Record Drawing

COVER SHEET SANITARY SEWER PLANS	2019
	EE'S SUMMIT MO

WOODSIDE RIDGE
FIRST PLAT

SHEET
C212

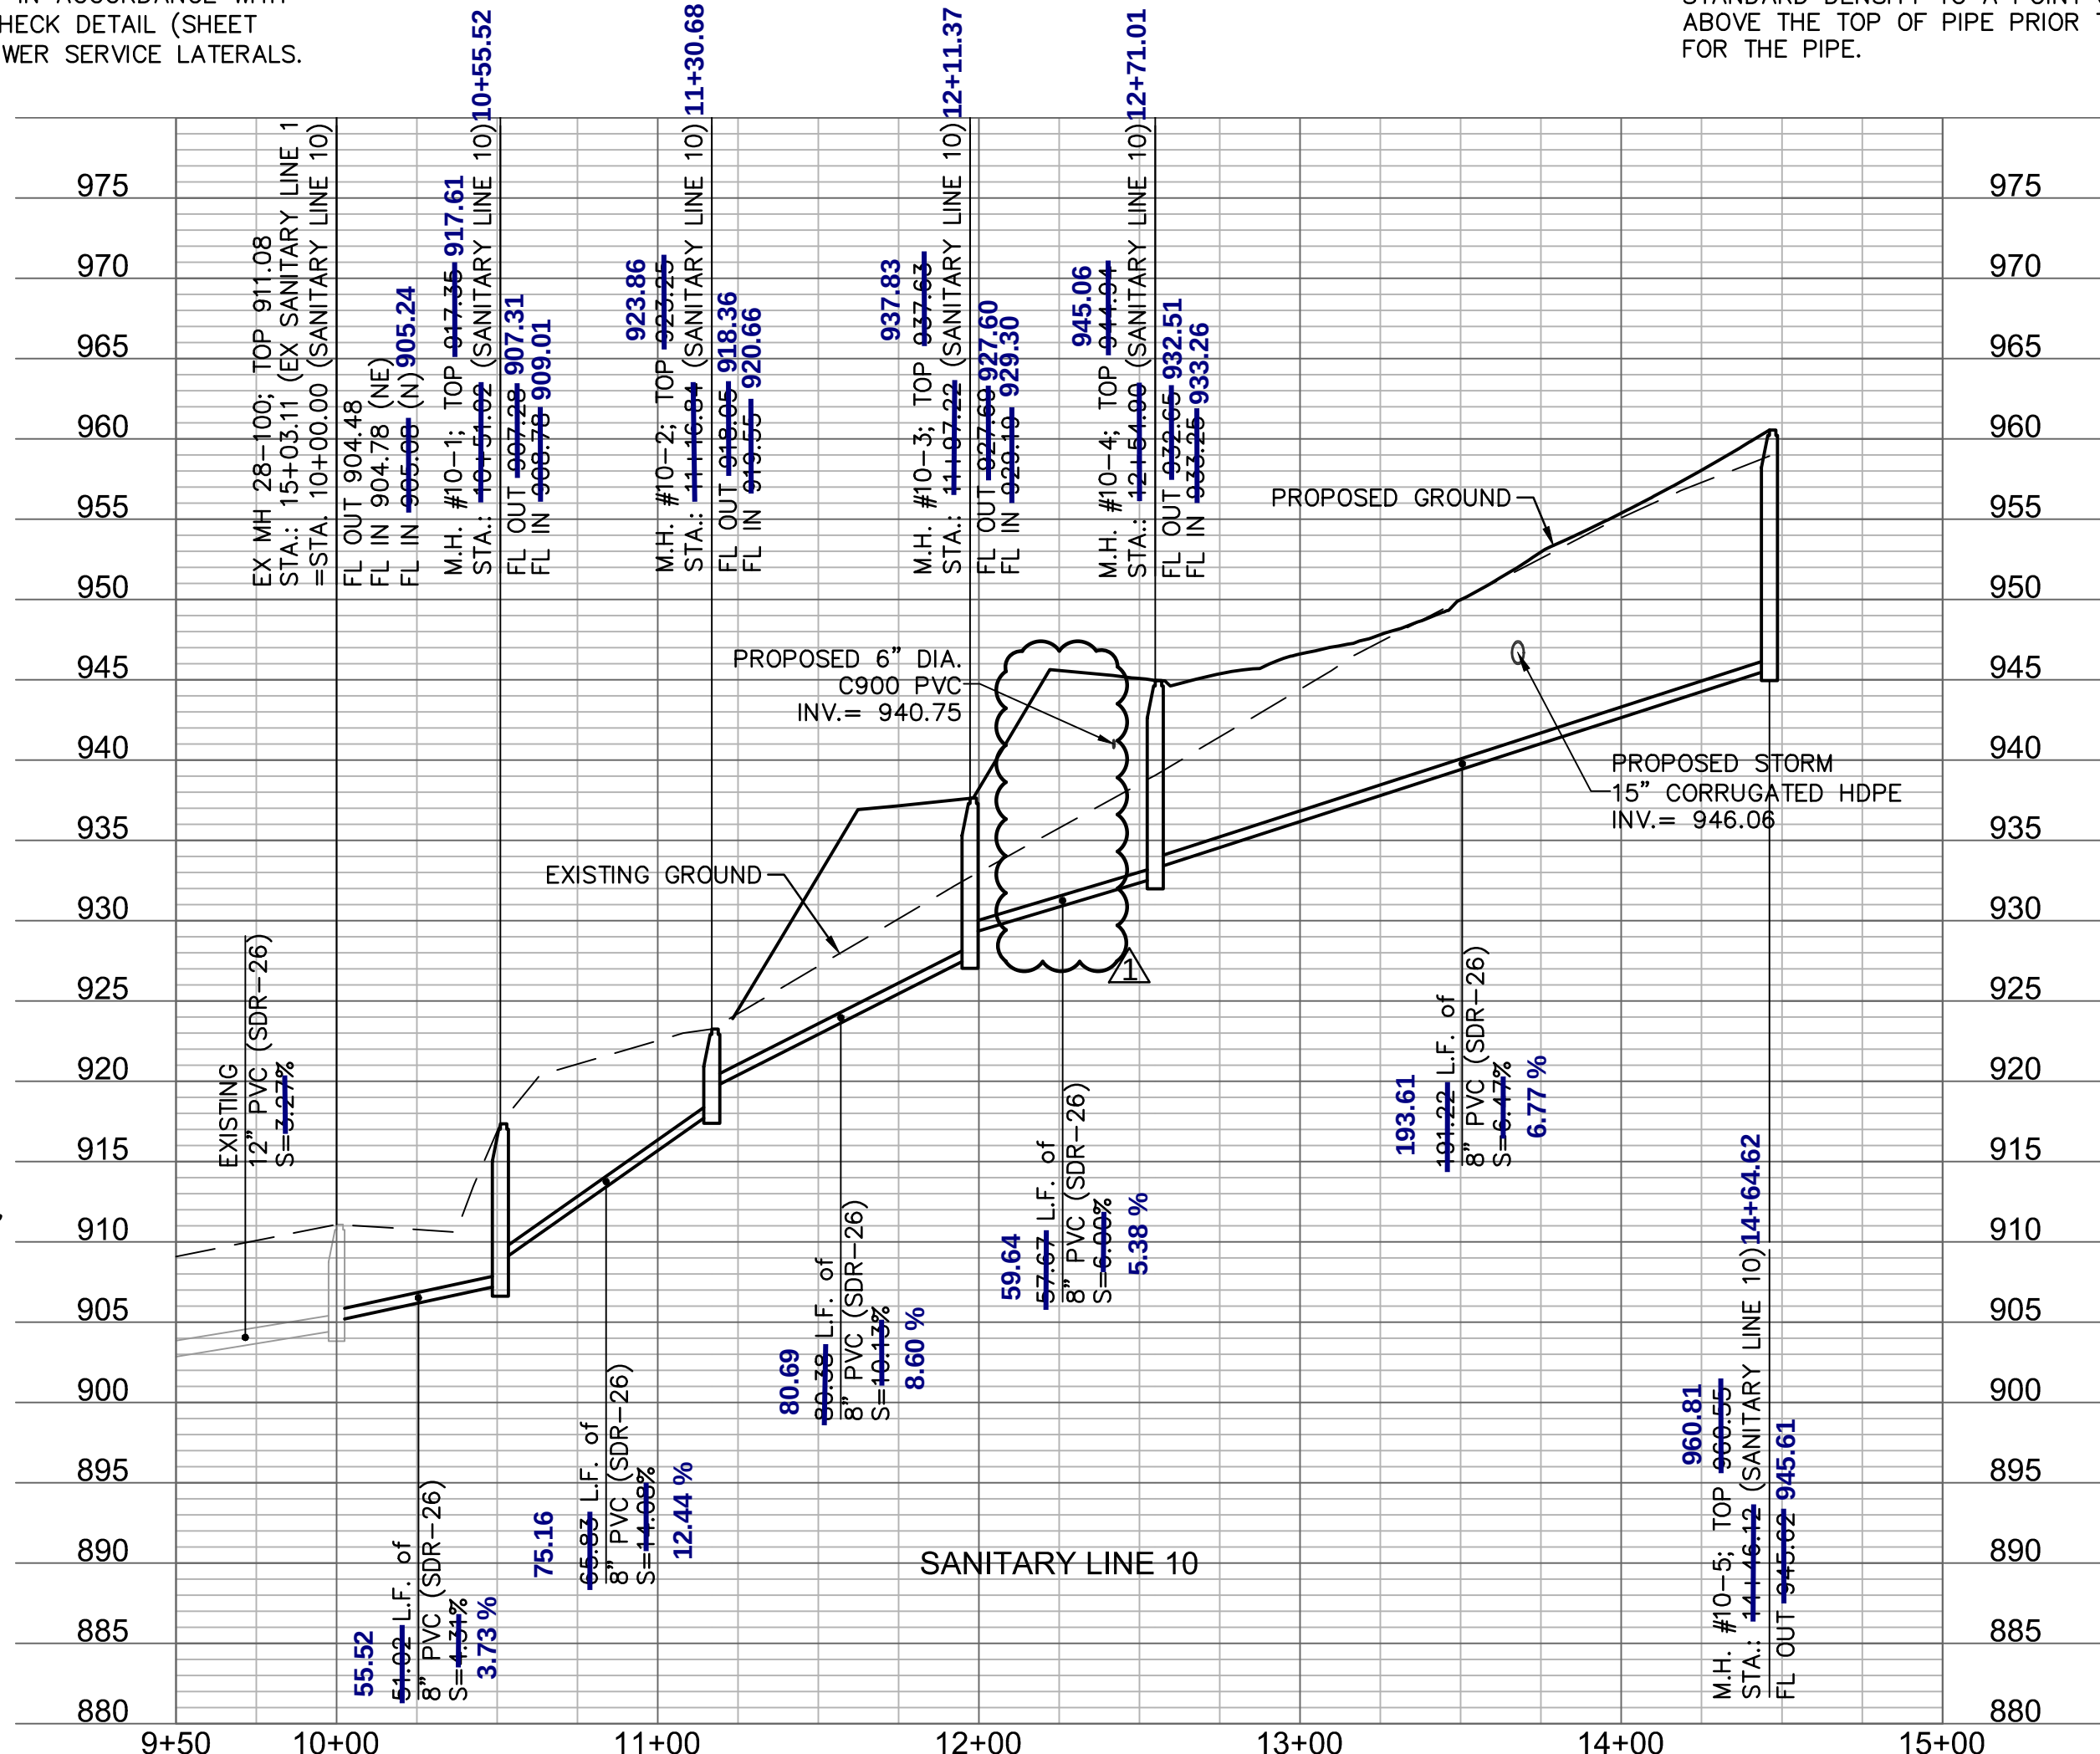
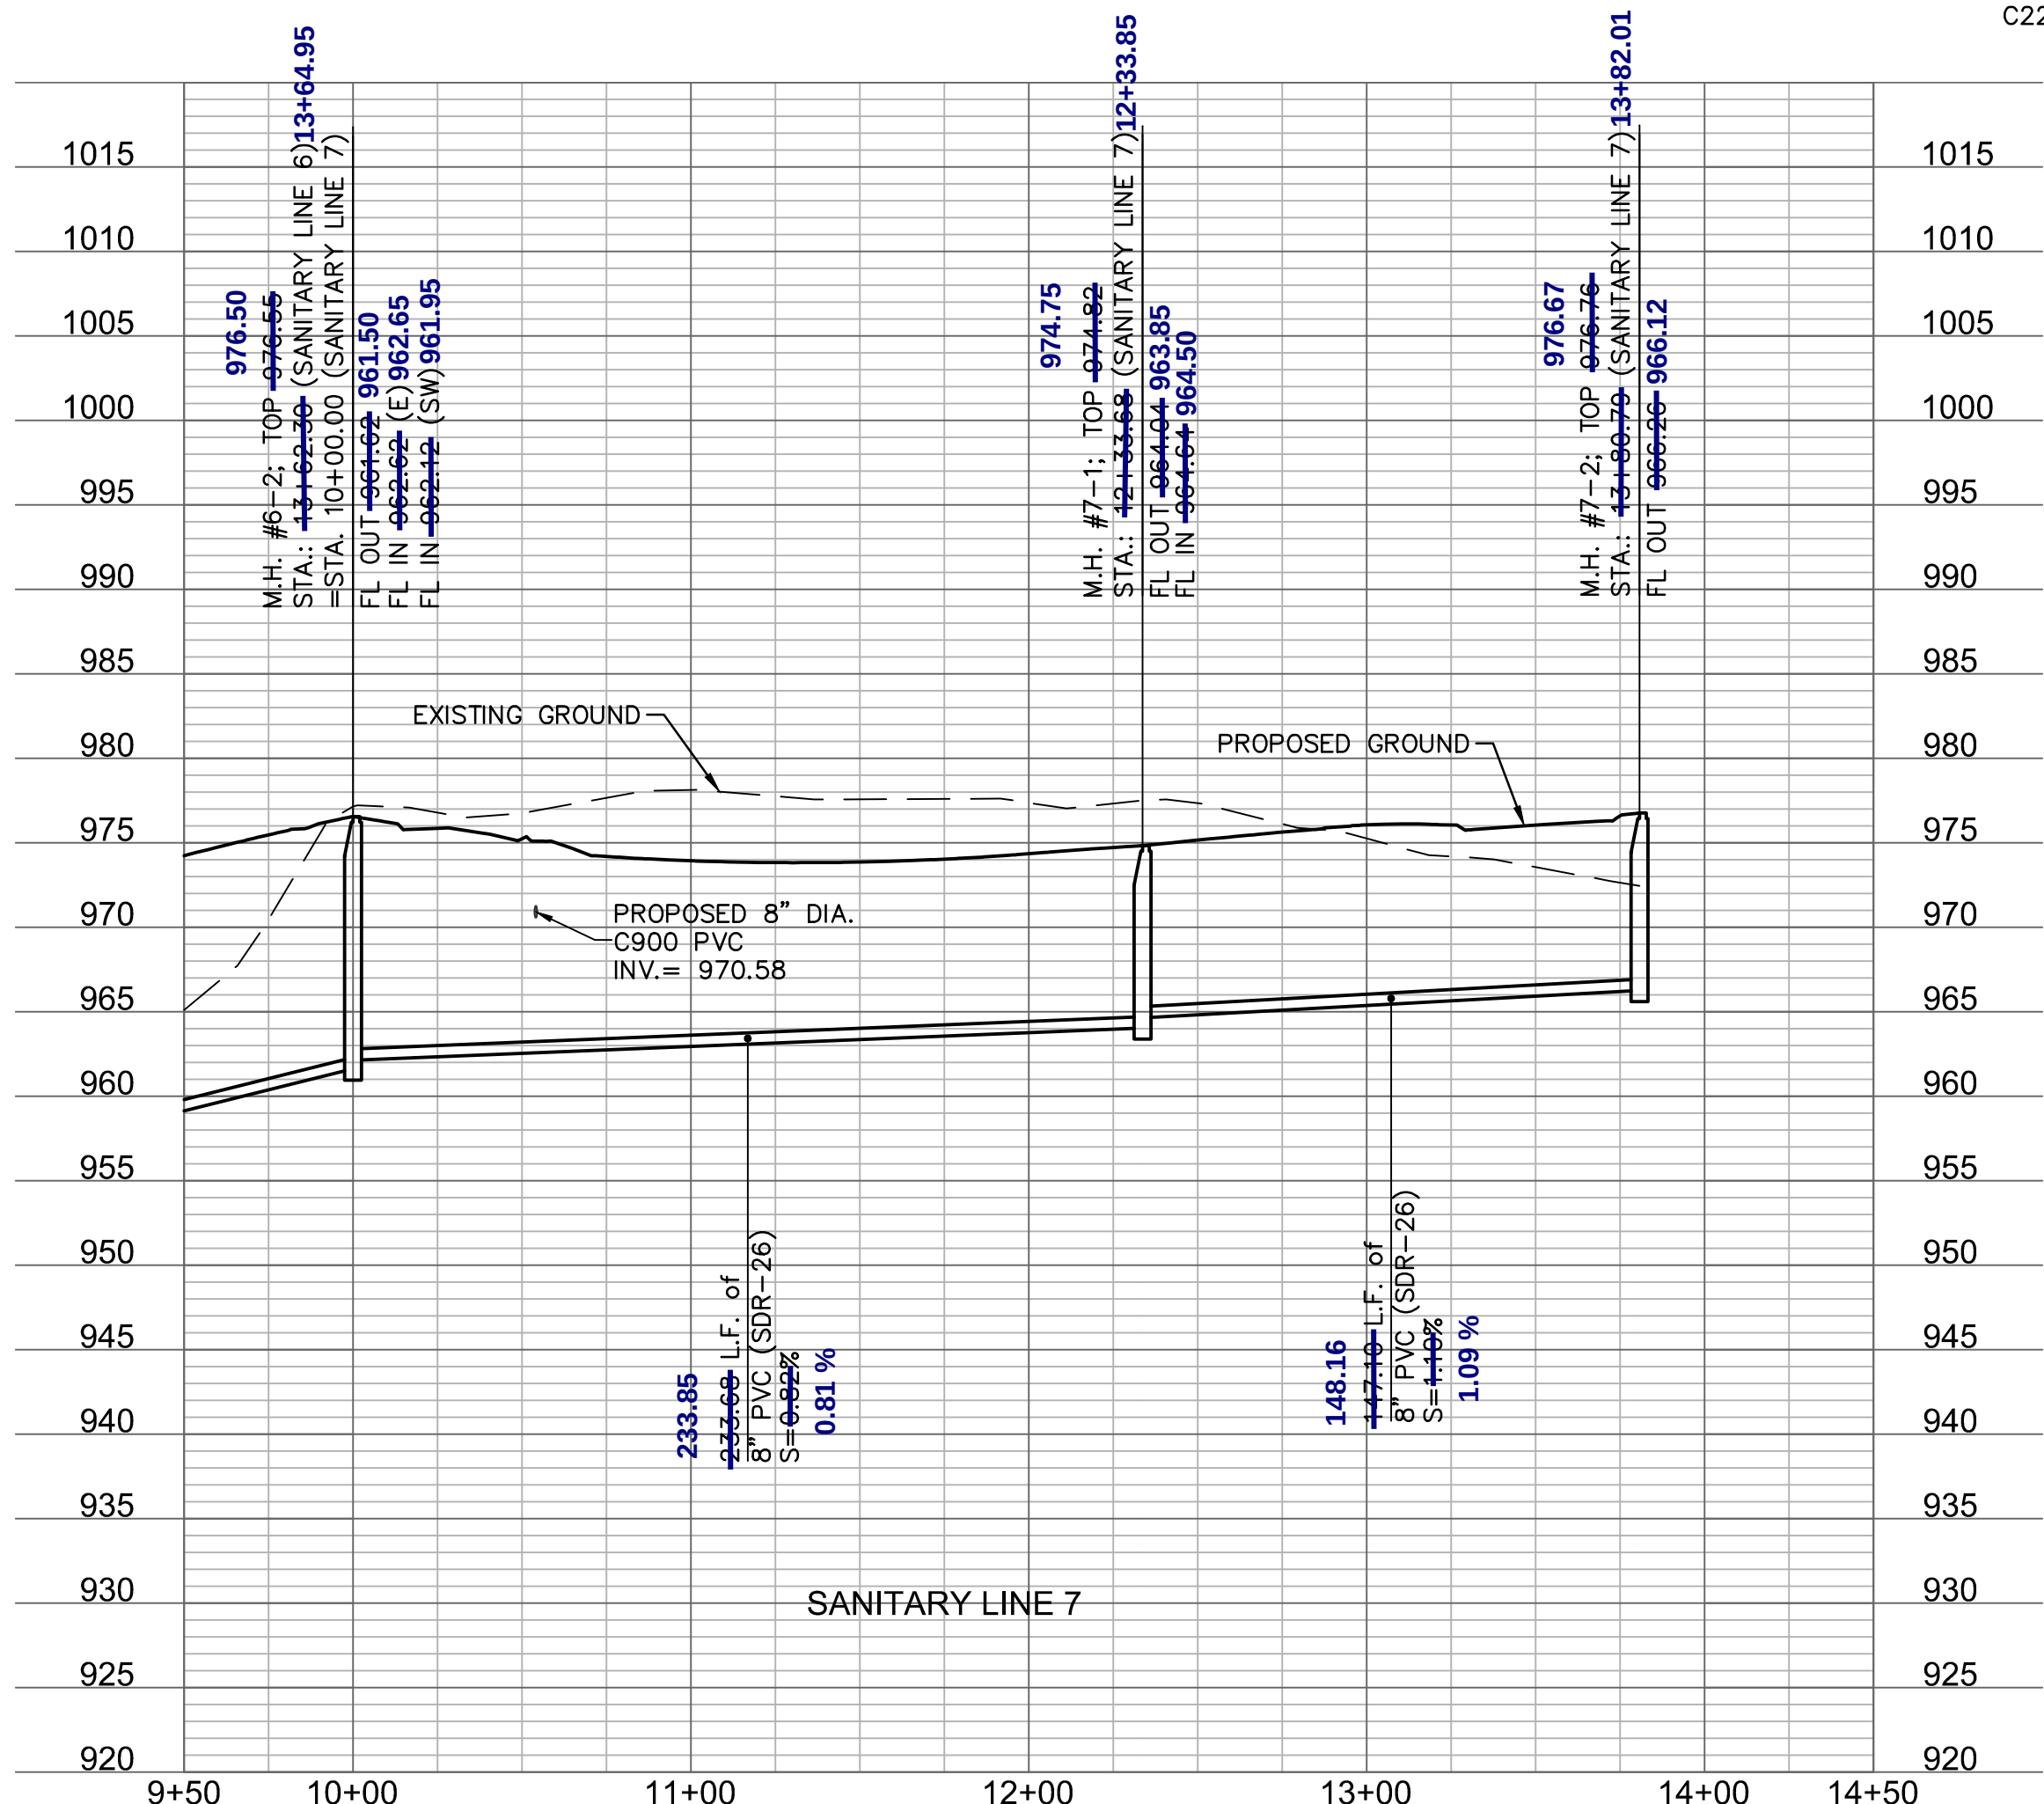
As-built is 0.09' N and
2.31' E of plan
M.H. #6-2, CONST. STD.
SANITARY MANHOLE (4' DIA. INSIDE)
STA.: ~~13+62.30~~ (SANITARY LINE 6)
=STA.: 10+00.00 (SANITARY LINE 7)
=STA.: ~~13+47.43~~ (C) ~~13+49.87~~ ~~28.12'~~
NW SHAMROCK AVENUE, ~~27.32'~~ LT

As-built is 0.14' N and
0.58' W of plan
M.H. #7-2, CONST. STD.
SANITARY MANHOLE (4' DIA. INSIDE)
STA.: ~~13+80.79~~ (SANITARY LINE 7)
=STA.: ~~10+48.14~~ (C) ~~10+48.25~~
NW GRADY COURT, ~~28.66'~~ RT ~~27.42'~~

As-built is 1.71' N and
10.51' W of plan
M.H. #10-2, CONST. FLAT TOP
SANITARY MANHOLE (4' DIA. INSIDE)
STA.: ~~11+16.84~~ (SANITARY LINE 10)
N: ~~1,003,097.0286~~ ~~1003098.74'~~
E: ~~2,812,246.2060~~ ~~2812235.70'~~

As-built is 0.56' S and
1.90' W of plan
M.H. #10-3, CONST. STD.
SANITARY MANHOLE (4' DIA. INSIDE)
STA.: ~~11+97.22~~ (SANITARY LINE 10)
=STA.: ~~10+63.37~~ (C) ~~10+62.72~~
NW KAYLEA COURT, ~~5.01'~~ RT ~~4.04'~~

As-built is 0.65' N and
1.18' E of plan
M.H. #10-4, CONST. STD.
SANITARY MANHOLE (4' DIA. INSIDE)
STA.: ~~12+54.90~~ (SANITARY LINE 10)
=STA.: ~~11+19.97~~ (C) ~~11+20.67~~
NW KAYLEA COURT, ~~16.06'~~ RT ~~18.11'~~

As-built is 3.02' N and
1.42' E of plan
M.H. #10-5, CONST. STD.
SANITARY MANHOLE (4' DIA. INSIDE)
STA.: ~~11+46.12~~ (SANITARY LINE 10)
=STA.: ~~13+10.90~~ (C) ~~13+13.98~~
NW KAYLEA COURT, ~~27.55'~~ RT ~~28.84'~~

As-built is 3.95' N and
0.50' W of plan
M.H. #10-1, CONST. STD.
SANITARY MANHOLE (4' DIA. INSIDE)
STA.: ~~10+51.92~~ (SANITARY LINE 10)
N: ~~1,003,081.4947~~ ~~1003085.45'~~
E: ~~2,812,310.1740~~ ~~2812309.68'~~

SHEET
C213

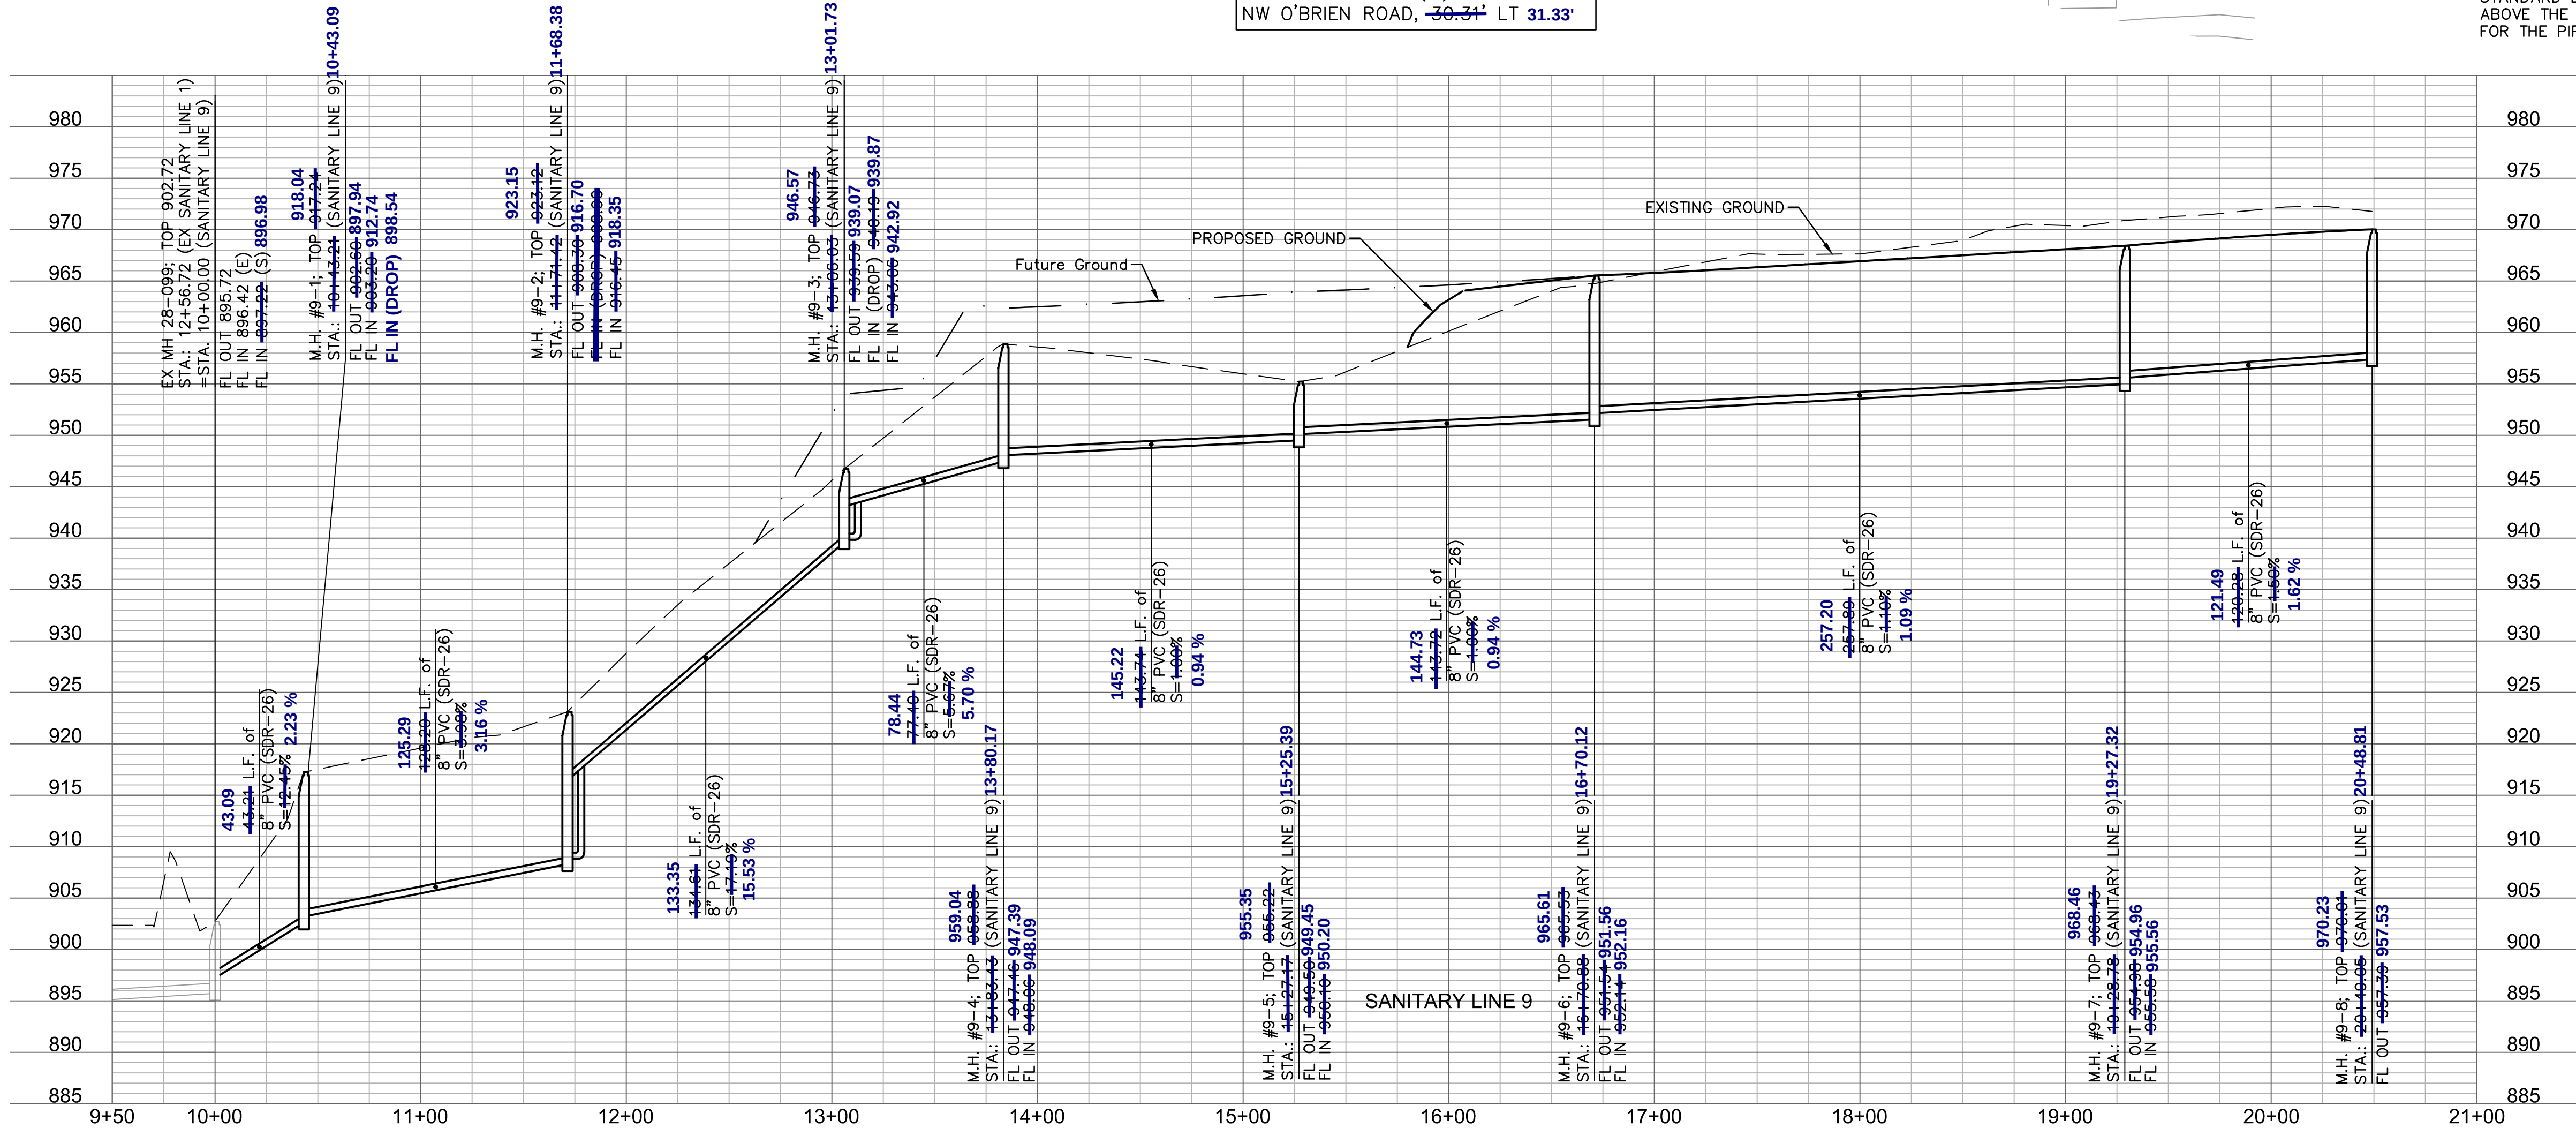
As-built is 0.19' N and
1.38' E of plan

M.H. #9-1, CONST. STD.
SANITARY MANHOLE (4' DIA. INSIDE)
STA.: ~~10+13.21~~ (SANITARY LINE 9)
N: ~~1,002,934.3100~~ 1002934.89'
E: ~~2,812,091.7676~~ 2812093.05'

As-built is 0.47' N and
1.24' W of plan

M.H. #9-3, CONST. DROP
SANITARY MANHOLE (4' DIA. INSIDE)
STA.: ~~13+06.03~~ (SANITARY LINE 9)
N: ~~1,002,797.4901~~ 1002797.97'
E: ~~2,812,259.6935~~ 2812258.44'

As-built is 0.76' S and
1.73' W of plan

M.H. #9-4, CONST. STD.
SANITARY MANHOLE (4' DIA. INSIDE)
STA.: ~~13+03.43~~ (SANITARY LINE 9)
N: ~~1,002,723.5923~~ 1002722.83'
E: ~~2,812,282.6703~~ 2812280.94'

As-built is 0' SN and
0' EW of plan

M.H. #9-2, CONST. DROP
SANITARY MANHOLE (4' DIA. INSIDE)
STA.: ~~11+71.42~~ (SANITARY LINE 9)
N: ~~1,002,926.0371~~ 1002925.02'
E: ~~2,812,219.7050~~ 2812217.95'

As-built is 0.69' N and
0.43' W of plan

M.H. #9-5, CONST. STD.
SANITARY MANHOLE (4' DIA. INSIDE)
STA.: ~~15+27.17~~ (SANITARY LINE 9)
N: ~~1,002,742.9364~~ 1002743.62'
E: ~~2,812,425.0992~~ 2812424.67'

As-built is 1.08' N and
0.68' E of plan

M.H. #9-6, CONST. STD.
SANITARY MANHOLE (4' DIA. INSIDE)
STA.: ~~16+70.88~~ (SANITARY LINE 9) 16+70.12
=STA.: ~~25+60.45~~ (C) 25+60.68
NW O'BRIEN ROAD, ~~37.49~~ LT 38.74'

As-built is 0.94' S and
0.66' E of plan

M.H. #9-8, CONST. STD.
SANITARY MANHOLE (4' DIA. INSIDE)
STA.: ~~20+49.06~~ (SANITARY LINE 9)
=STA.: ~~29+51.45~~ (C) 29+52.14
NW O'BRIEN ROAD, ~~38.50~~ LT 37.57'

As-built is 1.17' N and
0.05' W of plan

M.H. #9-7, CONST. STD.
SANITARY MANHOLE (4' DIA. INSIDE)
STA.: ~~19+28.70~~ (SANITARY LINE 9)
=STA.: ~~28+13.08~~ (C) 28+13.39
NW O'BRIEN ROAD, ~~30.31~~ LT 31.33'
